SUBJECT: Forwards responses ro Round One questions,Set 7 from Mechanical Engineering Branch.

Subject: WPPSS NUCLEAR PROJECT NO. 2
RESPONSES TO ROUND ONE QUESTIONS
SET 7 - MECHANICAL ENGINEERING BRANCH (MEB)

WPPSS NUCLEAR PROJECT NO. 2
RESPONSES TO ROUND ONE QUESTIONS
SET 7 - MECHANICAL ENGINEERING BRANCH (MEB)

WASHINGTON PUBLIC POWER SUPPLY SYSTEM NUCLEAR PROJECT NO. 2	MAIN STEAM TUNNEL, VENTWAY AND TUNNEL EXTENSION SECTIONAL PLAN	FIG. 3.6-127

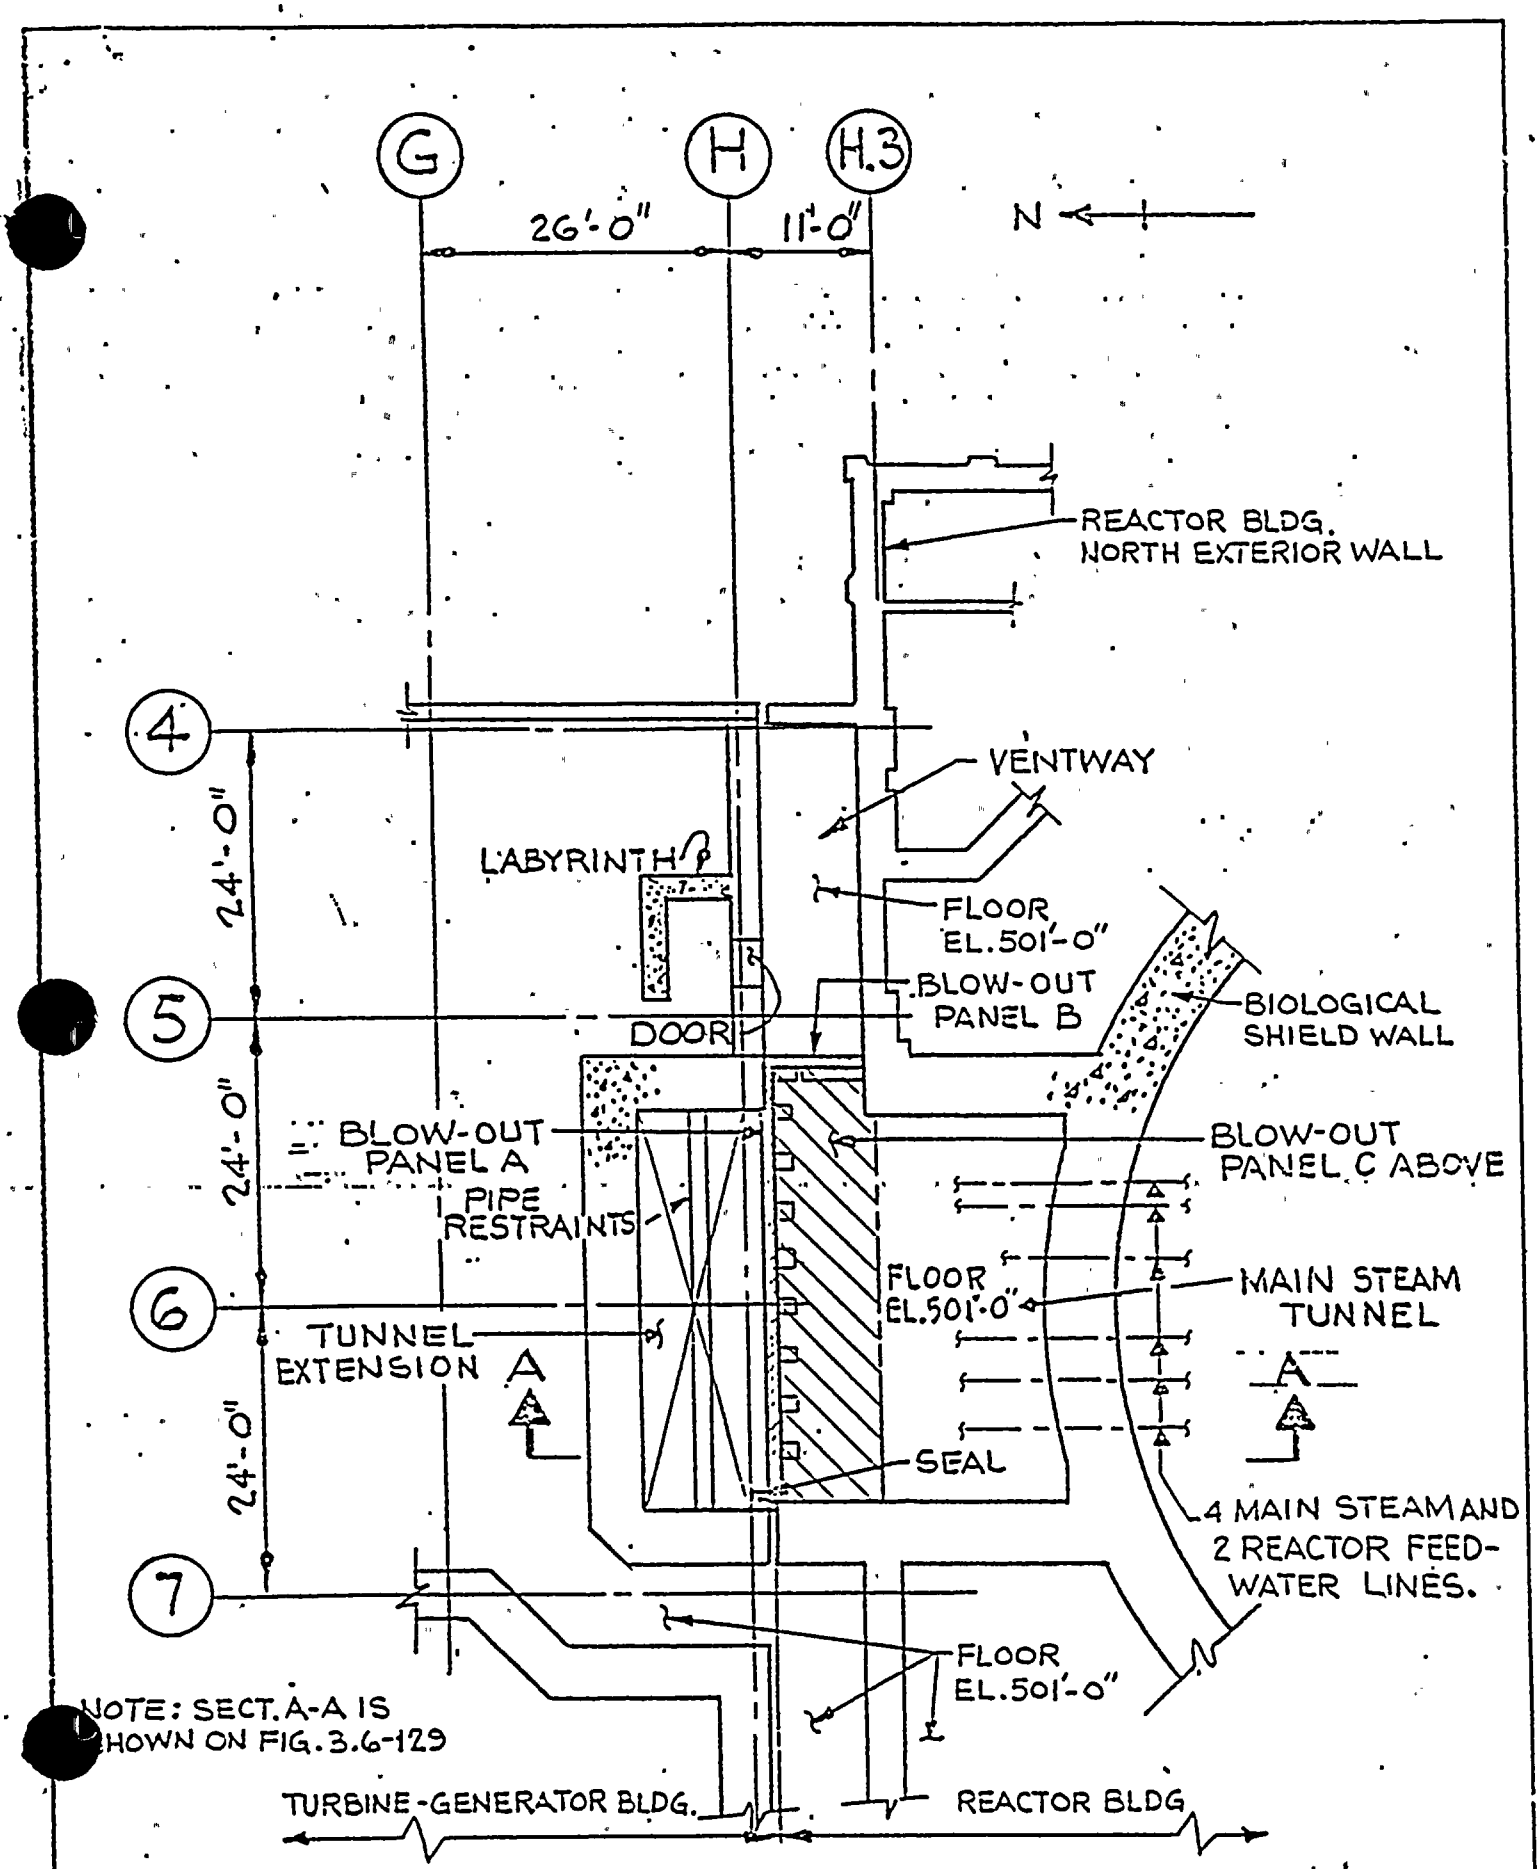
Descriptive information of the main steam tunnel, ventway and tunnel extension is provided in 3.8.4.1.1.4. Figures 3.6-127 and 3.6-128 show a sectional plan view and a sectional elevation view, respectively, of the main steam tunnel, ventway and tunnel extension.

FIGURE 3.6-129

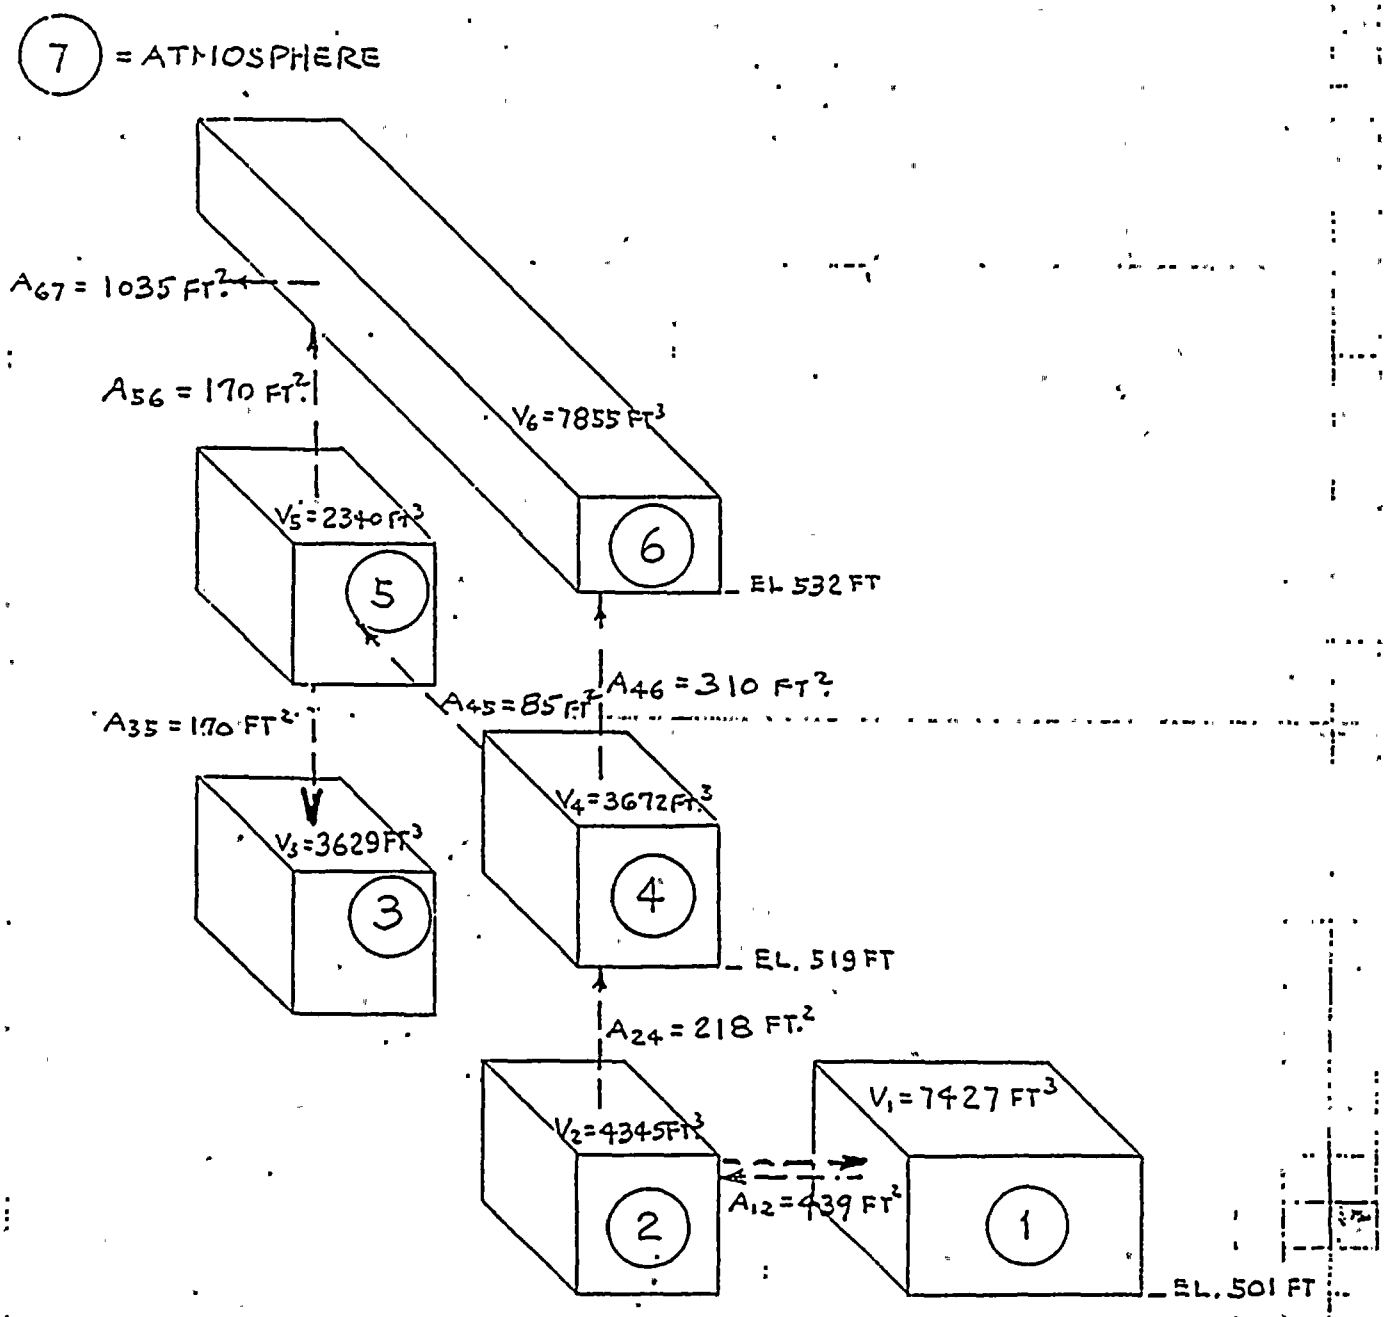
Figure 3.6-129 shows the nodalization scheme for a postulated pipe break in the main steam tunnel. For conservatism blow-out panels A and B are assumed to remain in place during the pressure transient. Therefore, the tunnel extension and the turbine generator building are not modeled in this case. Nodes 1 and 2 represent the main steam tunnel. Nodes 3, 4, 5 and 6 represent the ventway. Tables 3.6-13 and 3.6-14 provide the volume and flow junction data, respectively.

FIGURE 3.6-138

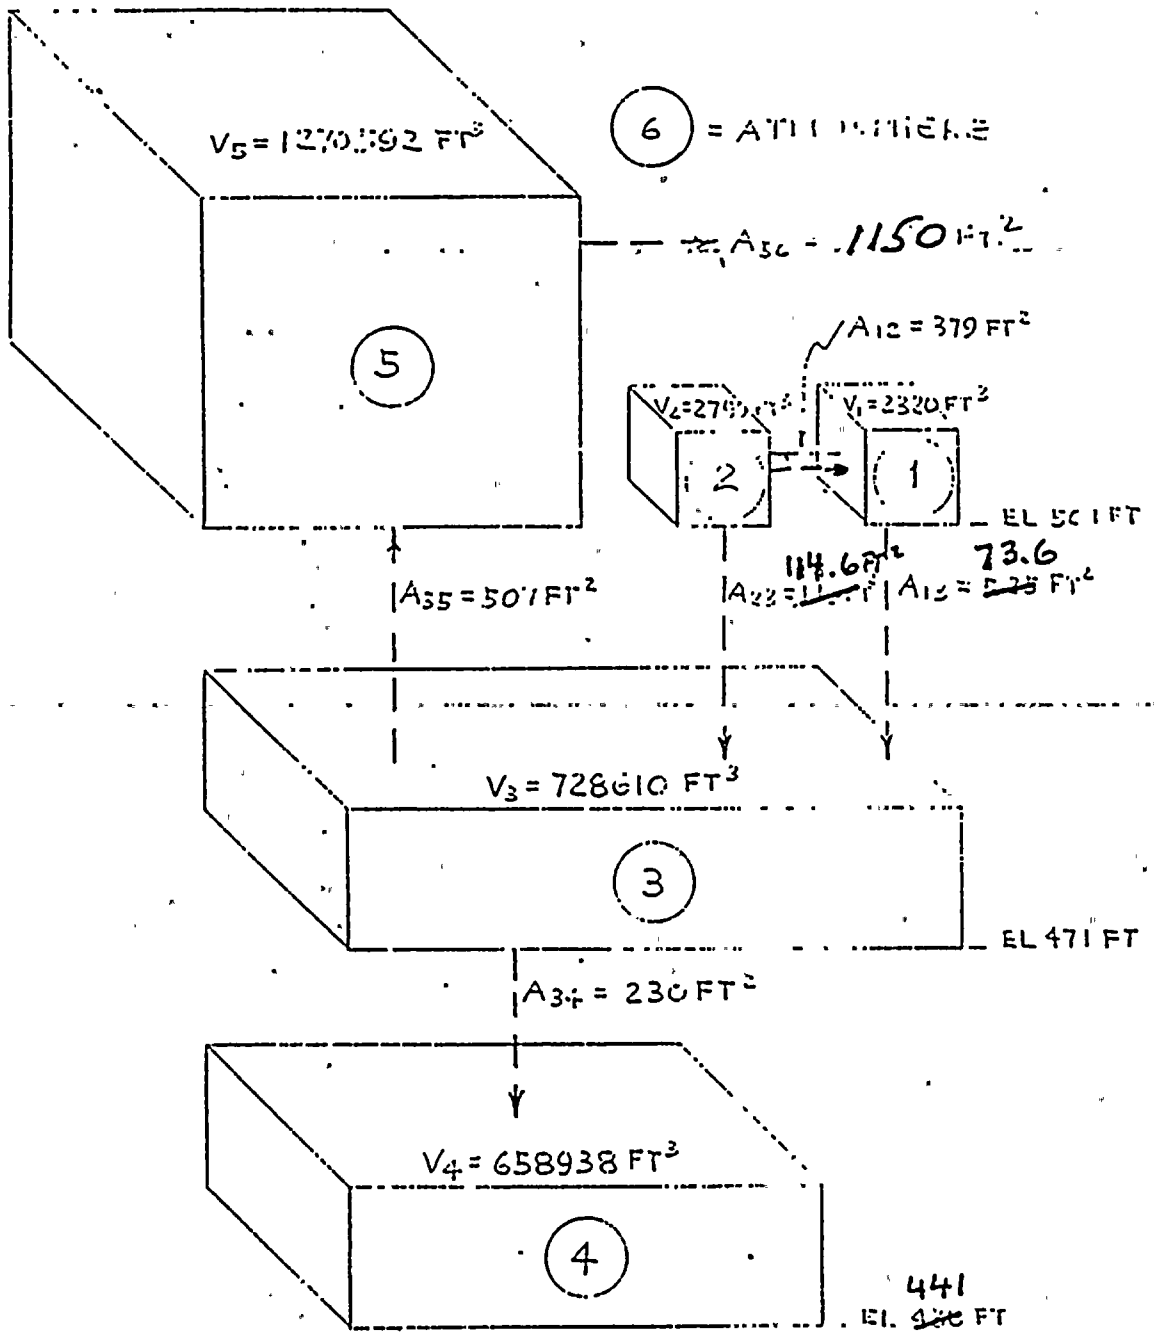
Figure 3.6-138 shows the nodalization scheme for a postulated pipe break in the tunnel extension. Nodes 1 and 2 represent the tunnel extension. The vertical pipe restraint (see Figures 3.6-6g, 3.6-6h, 3.6-6j and 3.6-6k) divides Node 1 and 2. Nodes 3, 4 and 5 represent the following portions of the turbine generator building:

WASHINGTON PUBLIC POWER SUPPLY SYSTEM NUCLEAR PROJECT NO. 2	STANDBY LIQUID CONTROL ISOMETRIC	FIGURE 3.6-19a

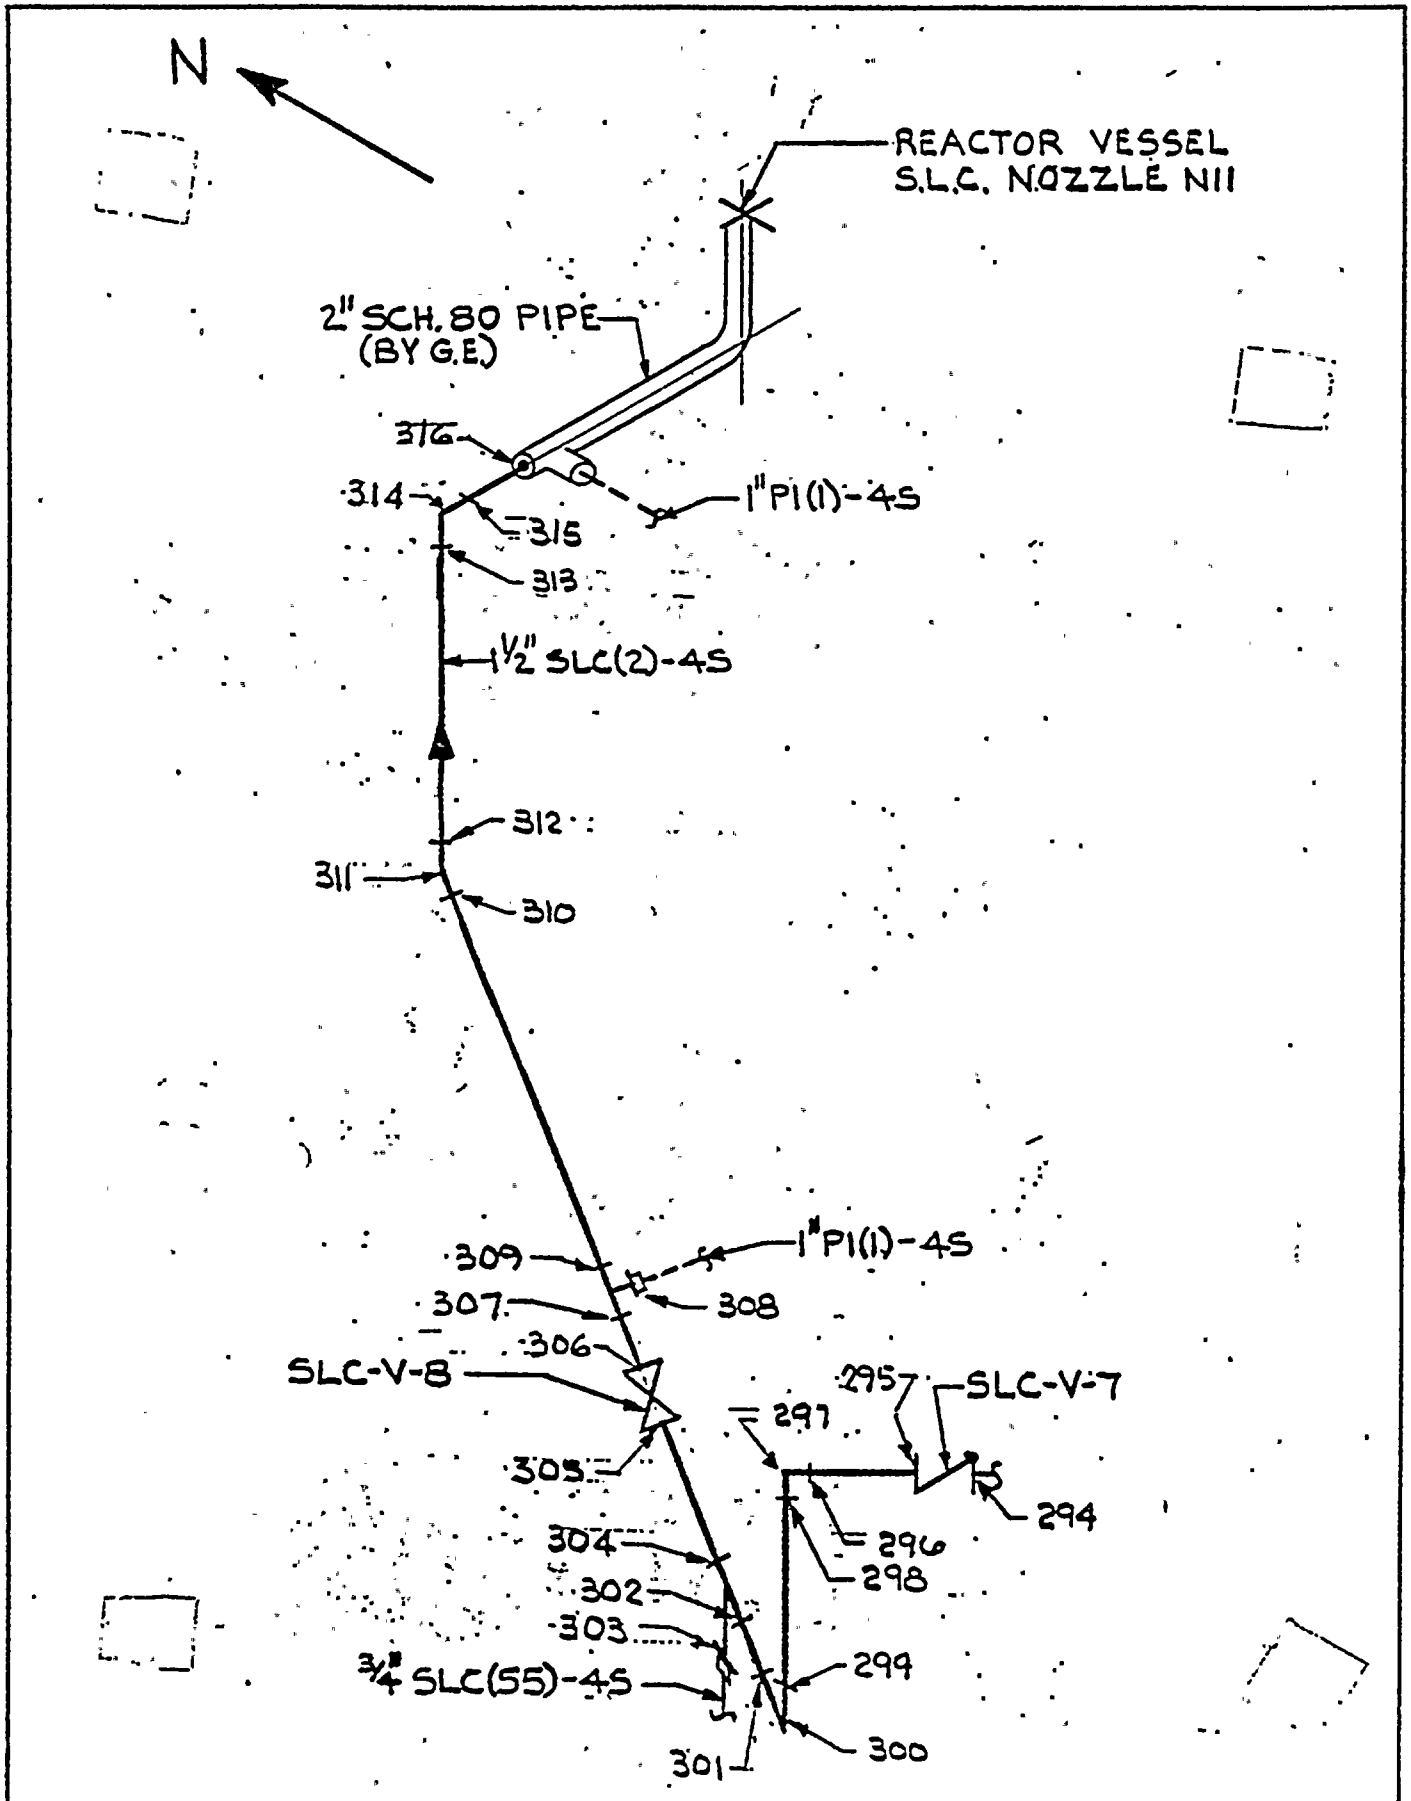
The postulated pipe breaks for the SLC system are shown in Figure 3.6-19a. Pipe whip restraints are not required for this system.
